POWER PLANT – NACELLE – POWERPLANT – GEARBOX BREATHER OUTLET – OVERBOARD GEARBOX VENT –
REPLACEMENT OR INSTALLATION OF. – CATEGORY CODE 4 – MOD.NAC-71-0046

V2500-NAC-71-0046

REPLACEMENT OF THE GEARBOX VENT
Fig.1

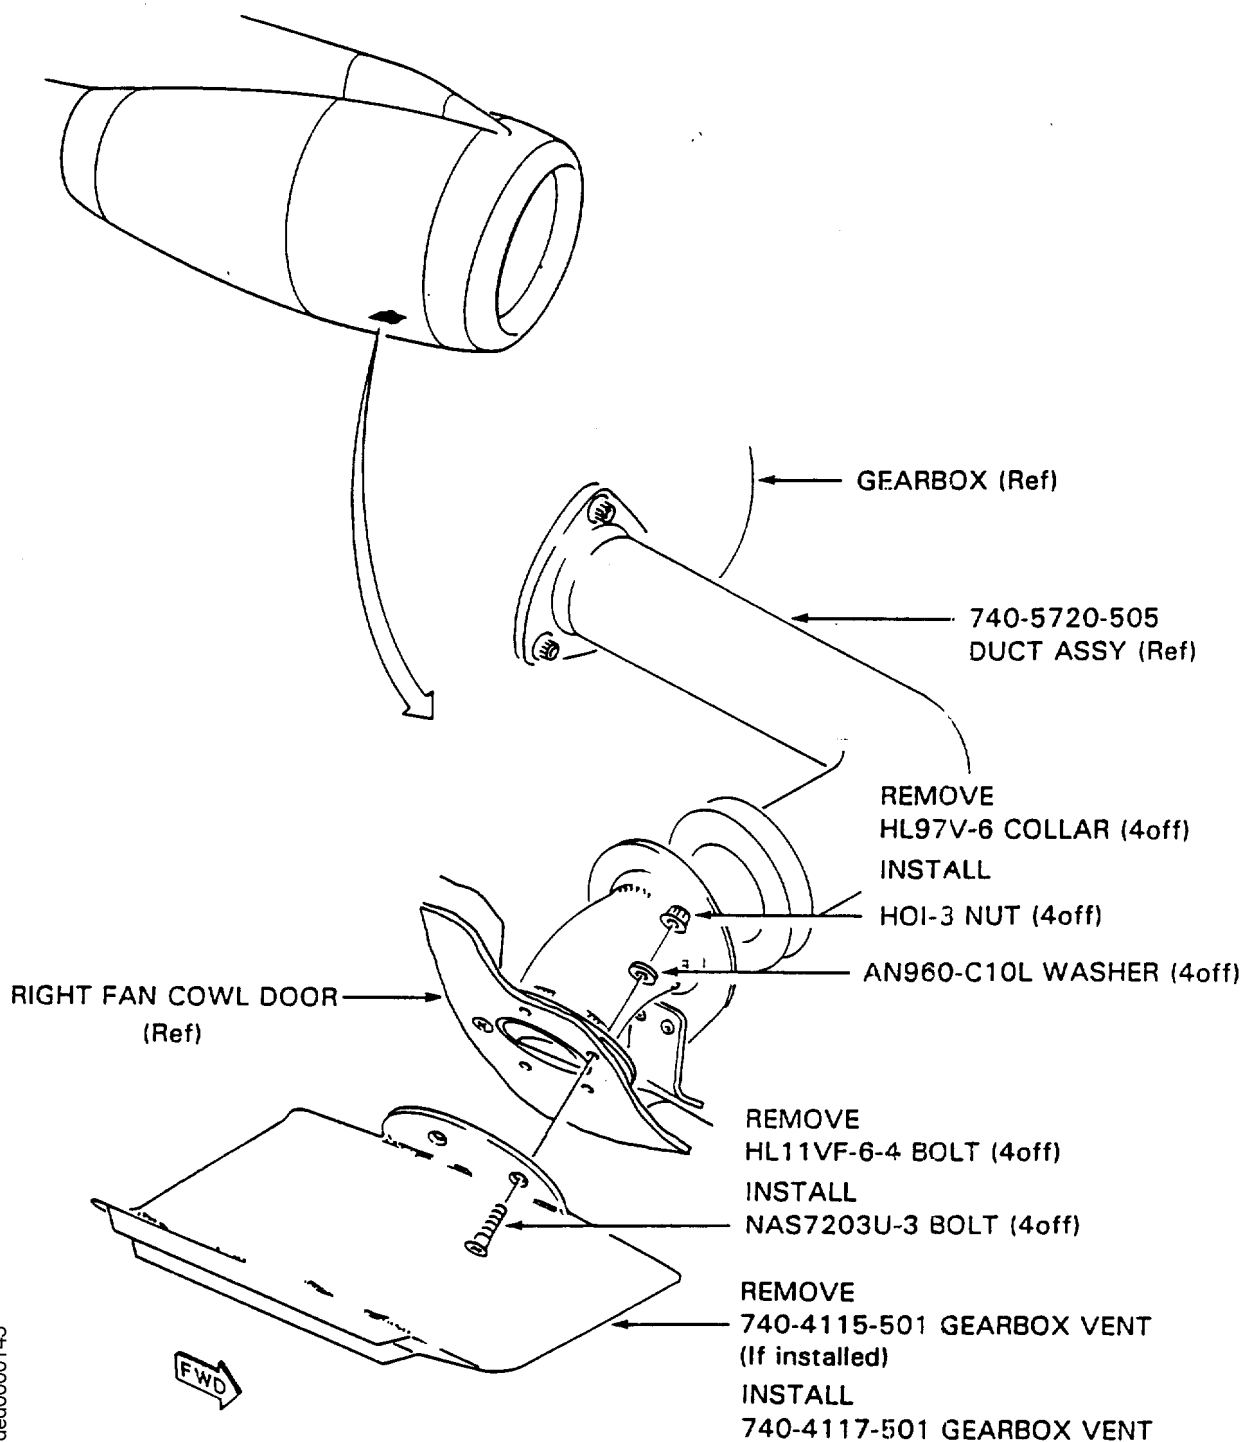
- (a) The gearbox breather vent, together with four Hi-lok bolts and collars, are removed from the right hand fan cowl door. A new gearbox breather vent is installed in its place with four bolts, four nuts and washers. Alternatively; for those nacelles without a gearbox vent; four Hi-lok bolts and collars are removed from the gearbox outlet and a 740-4117-501 gearbox vent installed with four bolts, nuts and washers.

- (1) Remove four HL11VF-6-4 Hi-lok bolts and four HL97V-6 Hi-lok collars to release the 740-4115-501 gearbox vent. (Refer to Illustrations 1 & 2). Discard the vent, bolts and collars.

- (3) Apply PL32 Hylomar to the base of the 740-4117-501 gearbox vent and install on the 740-4002- fan cowl door with four NAS7203U-3 bolts, four H01-3 nuts and four AN960-CLOL washers. Torque the nuts to 40 lbf in (4.52 Nm).
